Transmittal Memo

Re: Child Development Complex - Opel. La. (Electrical)

ELECTRICAL SERVICE WIRING DIAGRAM
N.T.S.

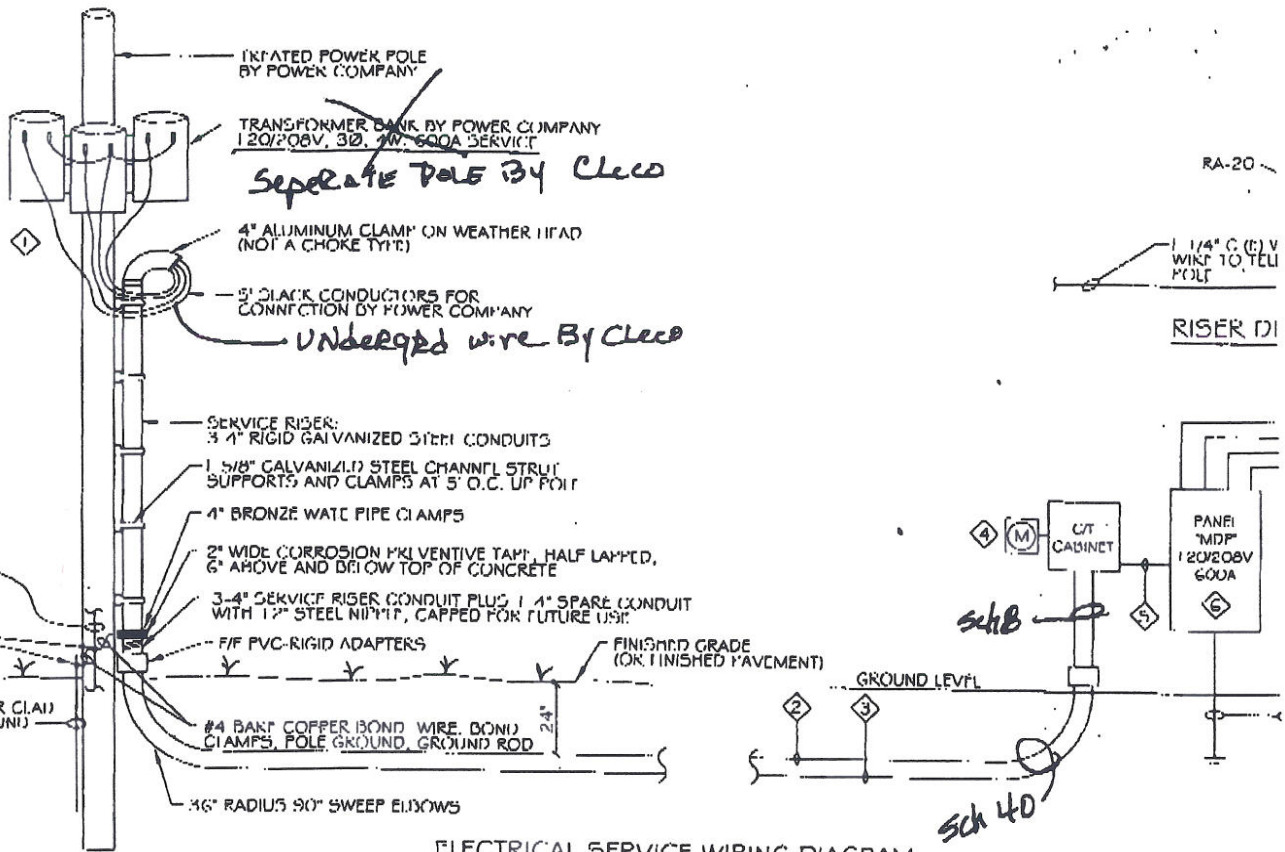
Remarks: We HAVE met w/ Checo Rep. - Needs 2-4# sch 40 MC and one spare to new pole location as shown on NOT PLAN OK.
